RFP-MCC-2313
Design / Build of Two Fire Stations
Addendum # 4

To All Bidders of RFP-MCC-2313:

aquaGEO™ Unidirectional Flushing Sequence Map

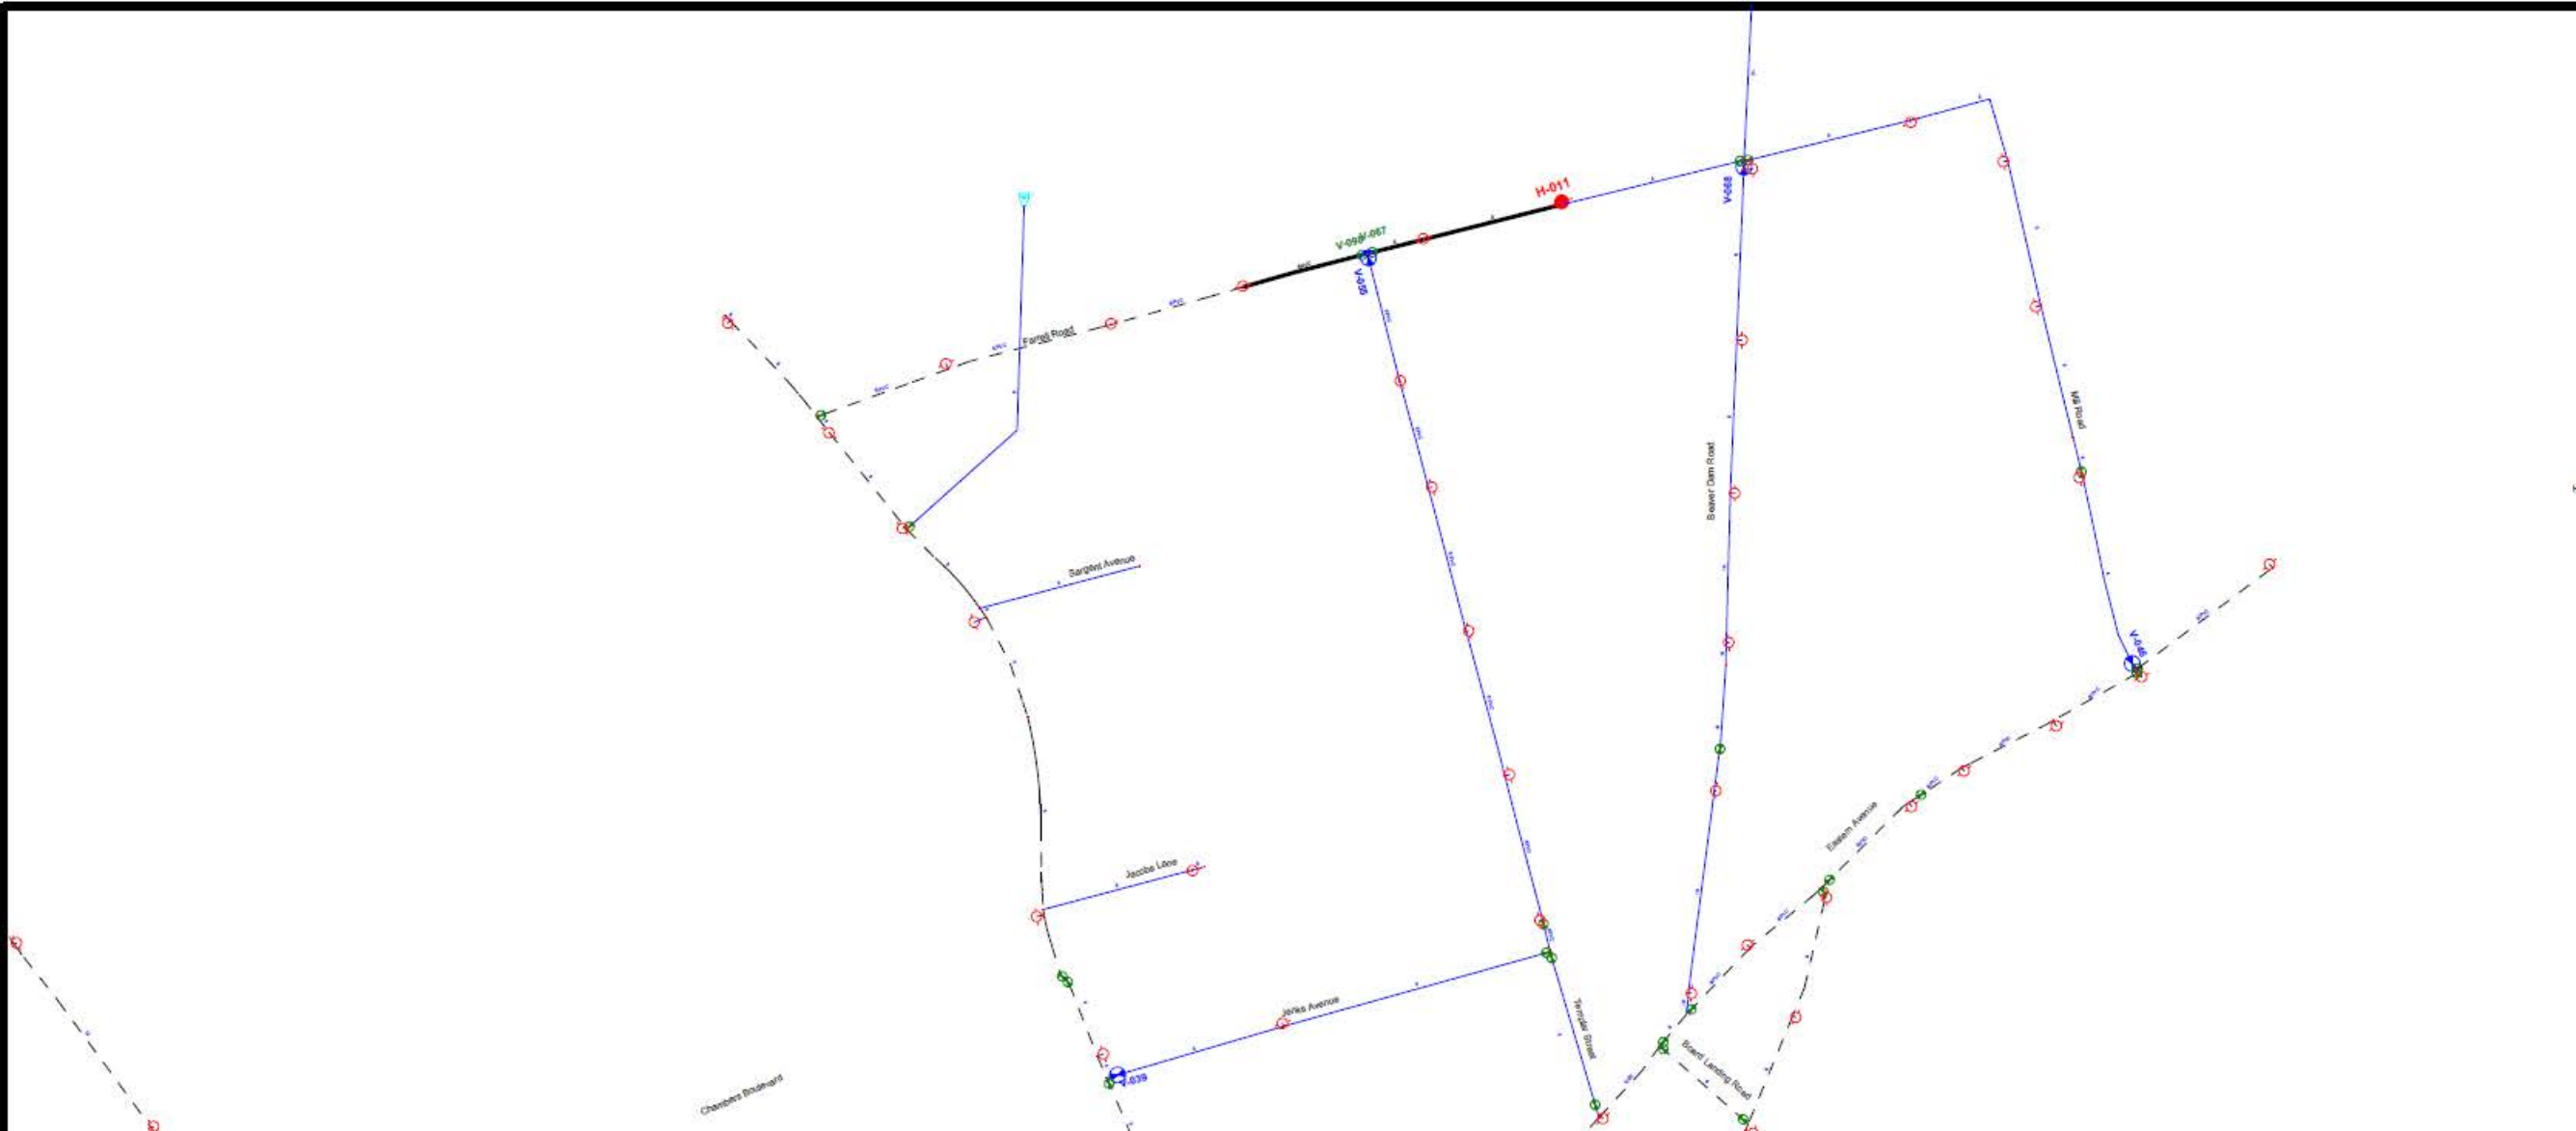
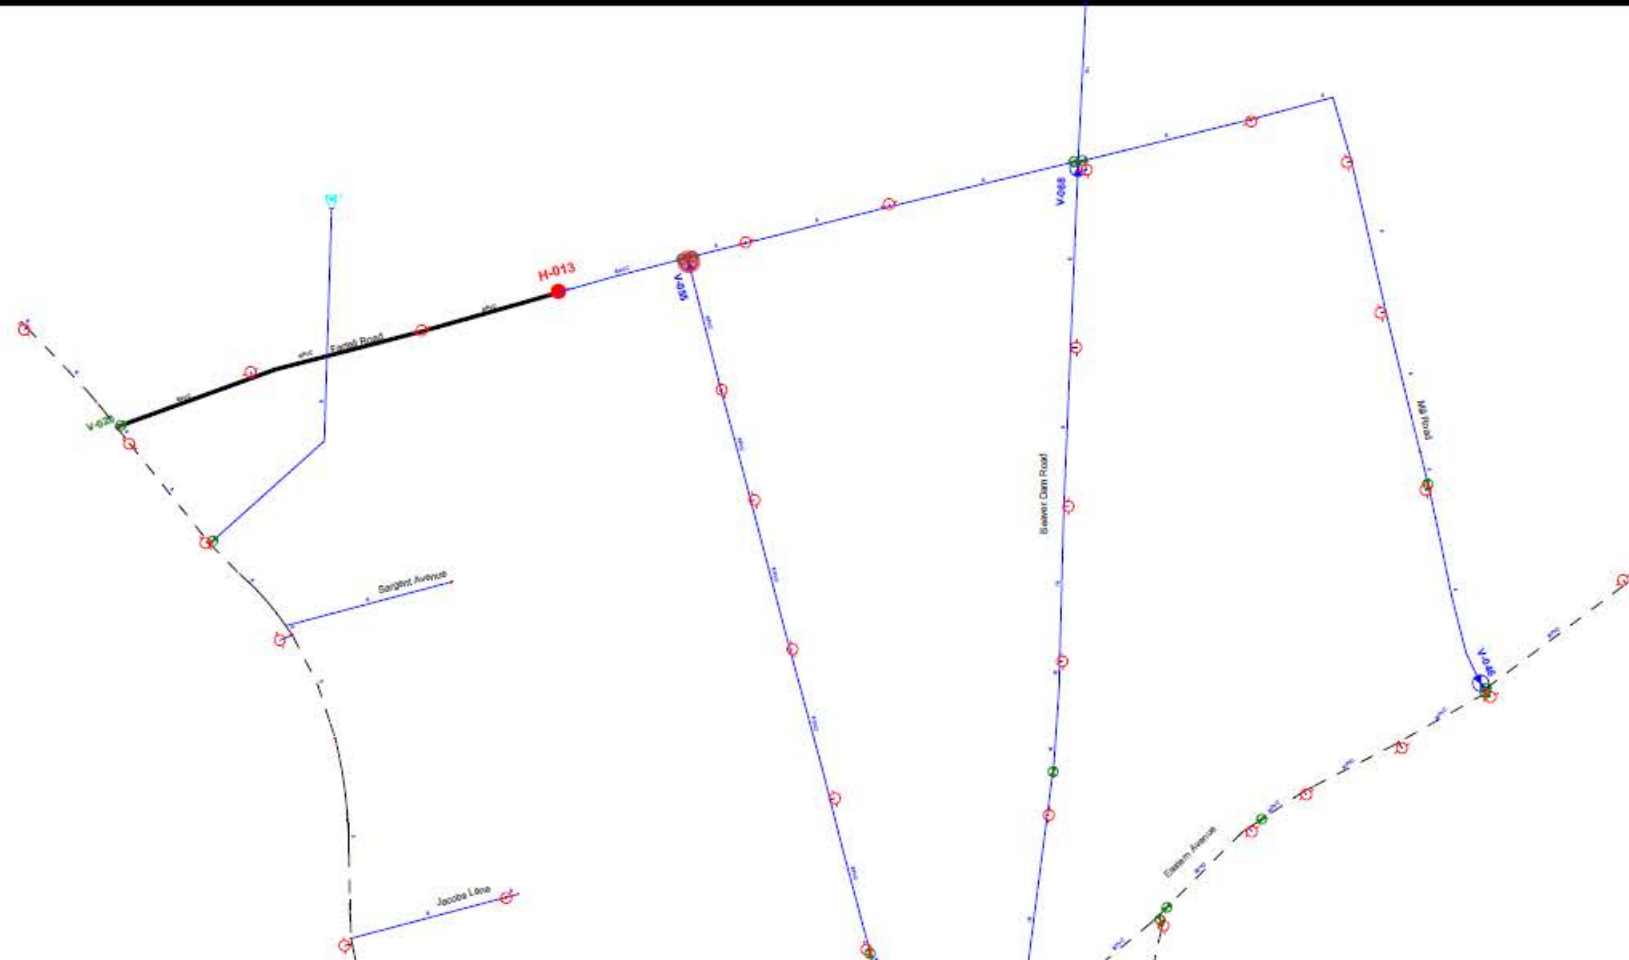
1. Attached you will find two Parrsboro site water pressure test maps. Information below:

H-013 - Static pressure = 62 PSI, Dynamic pressure = 31 PSI (780 USgal/min)

H-011 - Static pressure = 73 PSI, Dynamic pressure = 31 PSI (780 USgal/min)

These are both done with a 2 1/2" 45* elbow diffuser.
